PrintServer 17/600 Printer

Maintenance Advisory

EK-PRT17-MA. A01

First Printing, March 1994

Figure 2–1 New V2.1 Controller Board Test Patterns

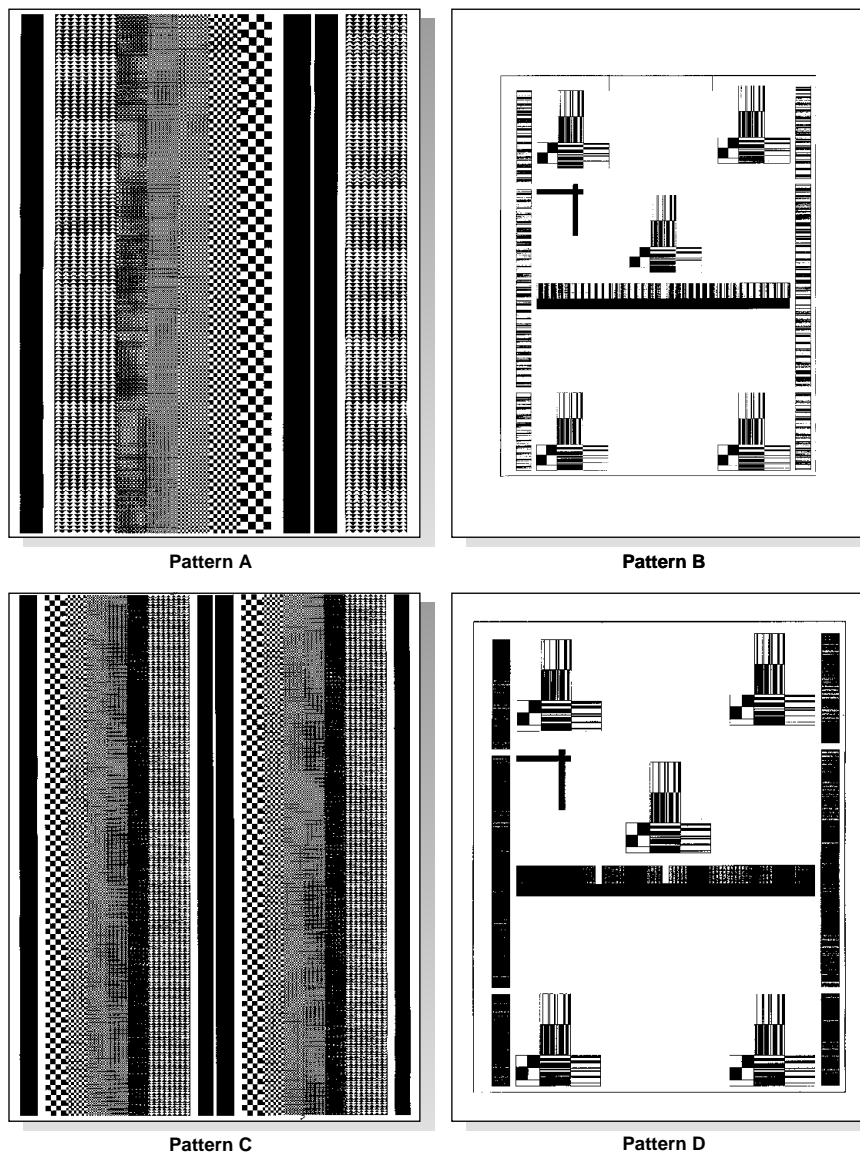
Figure 2–1 shows the 400 and 600 dpi test patterns that are printed by a PrintServer 17/600 printer. An example of the PrintServer 17 300 dpi pattern appears in Figure 4-2 of the service guide.

- Patterns A and B are printed at 400 dpi. Compare the B and D test test patterns. Notice how the B pattern is smaller on the page than pattern D. This only happens at 400 dpi.
- Patterns C and D are printed at 600 dpi. Compare the C and the A test patterns. Notice how the C test pattern is horizontally compressed. This compression effect increases as the density (dots-per-inch) increases.
